# **Assessment Report**

for the Amended Environmental  
Impact Statement

**Ceduna Keys Marina and  
Community Centre**

November 2011

DRAWING TITLE  
ROUNDABOUT TURNPATHS  
LEFT TURNS

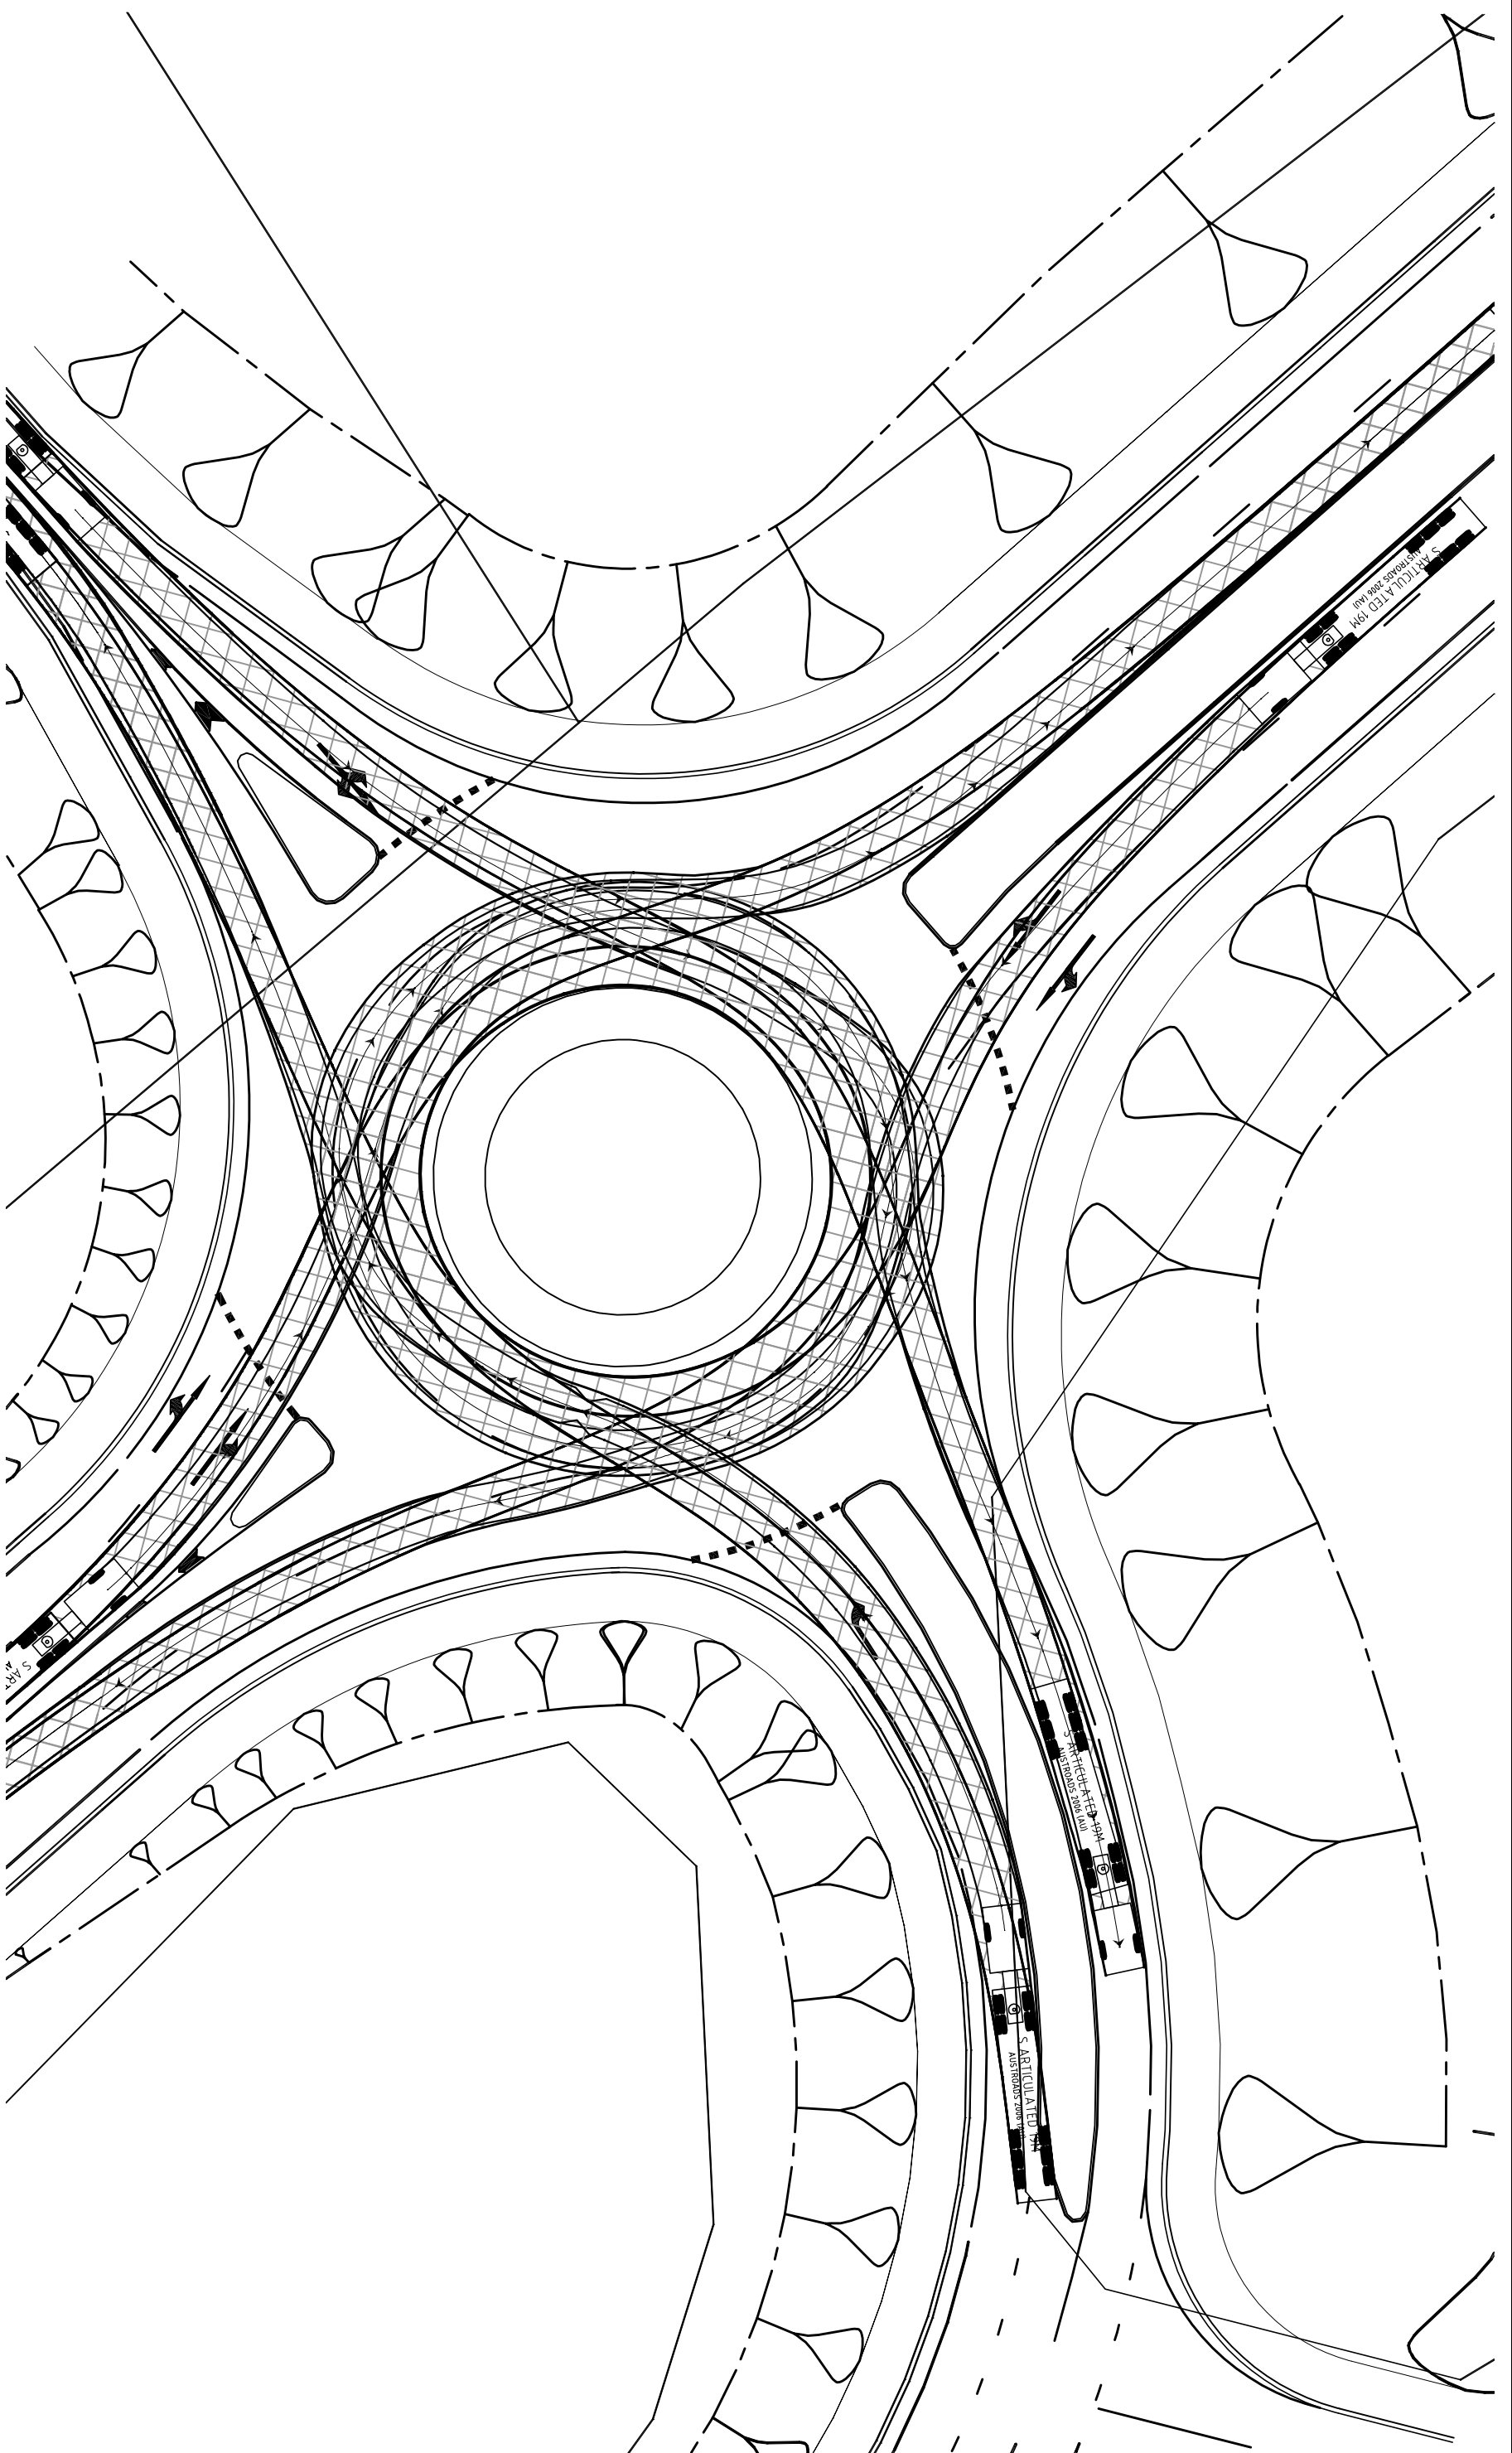
The proposed roundabout caters for left and right turning 19m semi vehicles as illustrated on plan SK 36\_left turn in Figure 1 and plan SK 36\_right turn in Figure 2. The roundabout caters for the through movement of the B-triple vehicles as illustrated on plan 106055 SK32 in Figure 3. The turnpaths have been modelled with a passenger vehicle travelling alongside the B-triple as the vehicles negotiate the roundabout. In reality this may not occur as the B-triple would tend to command both lanes.
